RS-01-052

Dresden Nuclear Power Station, Units 2 and 3  
Facility Operating License Nos. DPR-19 and DPR-25  
NRC Docket Nos. 50-237 and 50-249

Quad Cities Nuclear Power Station, Units 1 and 2  
Facility Operating License Nos. DPR-29 and DPR-30  
NRC Docket Nos. 50-254 and 50-265

Subject: Additional Electrical Information Supporting the License Amendment Request to Permit Up-rated Power Operation at Dresden Nuclear Power Station and Quad Cities Nuclear Power Station

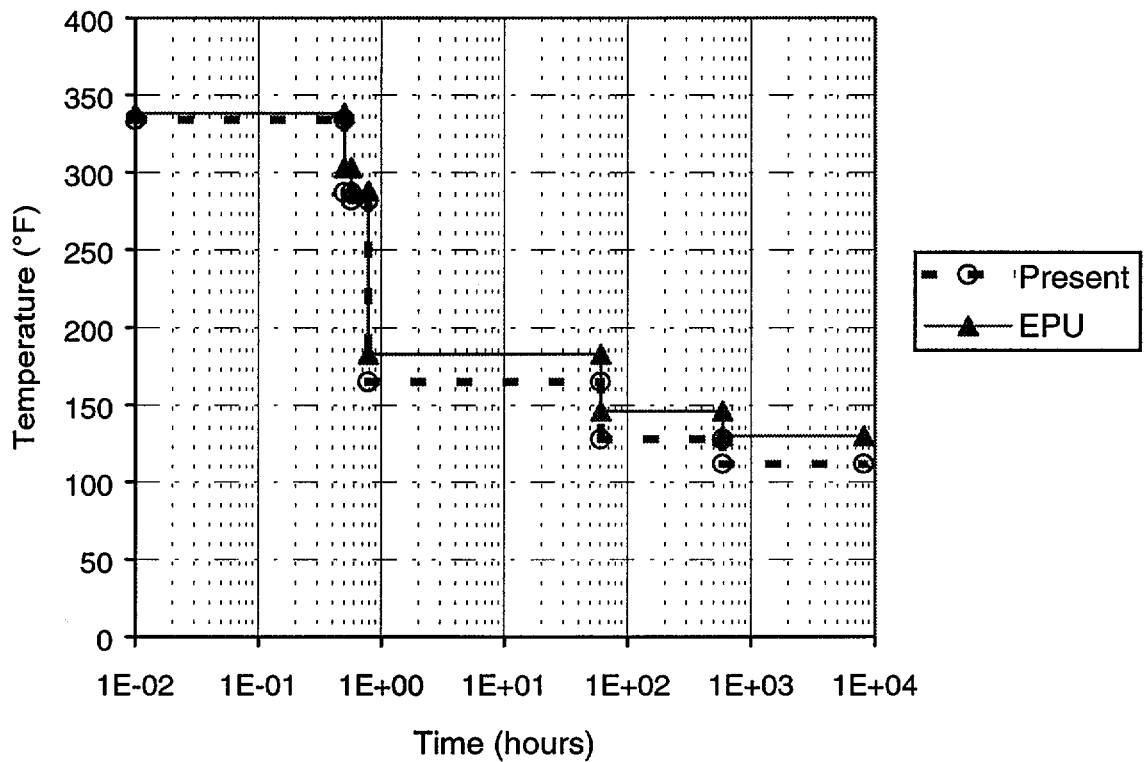
7. *In Section 10.3.1.1, the licensee stated that the current accident conditions for temperature and pressure are modified for the EPU conditions. Provide a discussion regarding the effect of modified temperature and pressure for the EPU conditions on environmental qualification (EQ) of electrical equipment inside containment.*

1. The present drywell peak pressure for qualification of 63 psia is bounding for the EPU condition.
2. The present and EPU drywell temperature profiles used for EQ are shown in the table and figure on the following page.

For all equipment inside the containment within the EQ program, evaluations were performed to demonstrate that the existing environmental documentation was adequate to meet the revised temperature and pressure values due to EPU. Evaluations were done for each equipment type using the following approach.

1. The qualification test temperature conditions for the required operability period during the first 24 hours following a LOCA were shown to envelop the corresponding EPU temperature profile.
2. The qualification test temperature conditions for the required operability period beyond 24 hours to 1 year following a LOCA were shown to meet the revised EPU temperature profile using Arrhenius methodology.
3. Maximum test pressure was shown to envelop the revised peak pressure for EPU.

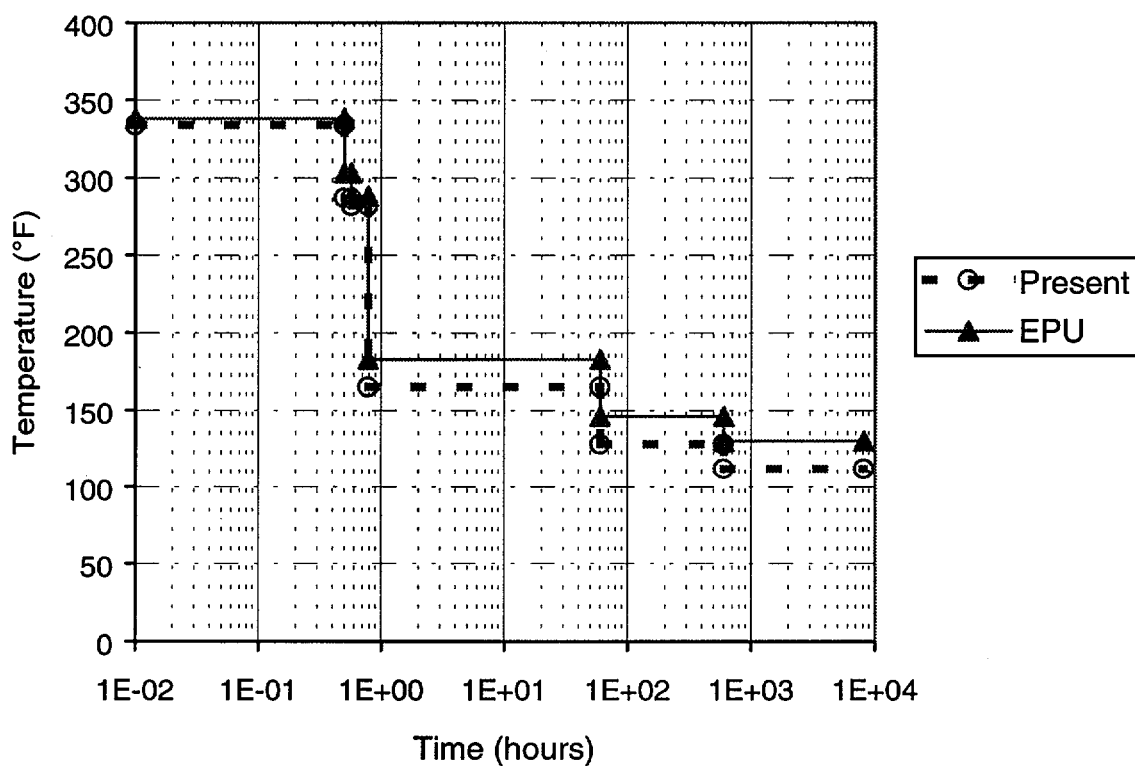
7. *In Section 10.3.1.1, the licensee stated that the current accident conditions for temperature and pressure are modified for the EPU conditions. Provide a discussion regarding the effect of modified temperature and pressure for the EPU conditions on environmental qualification (EQ) of electrical equipment inside containment.*

1. The present drywell peak pressure for qualification of 63 psia is bounding for the EPU condition.
2. The present and EPU drywell temperature profiles used for EQ are shown in the table and figure below.

For all equipment inside the containment within the EQ program, evaluations were performed to demonstrate that the existing environmental documentation was adequate to meet the revised temperature and pressure values due to EPU. Evaluations were done for each equipment type using the following approach.

1. The qualification test temperature conditions for the required operability period during the first 24 hours following a LOCA were shown to envelop the corresponding EPU temperature profile.
2. The qualification test temperature conditions for the required operability period beyond 24 hours to 1 year following a LOCA were shown to meet the revised EPU temperature profile using Arrhenius methodology.

3. Maximum test pressure was shown to envelop the revised peak pressure for EPU.
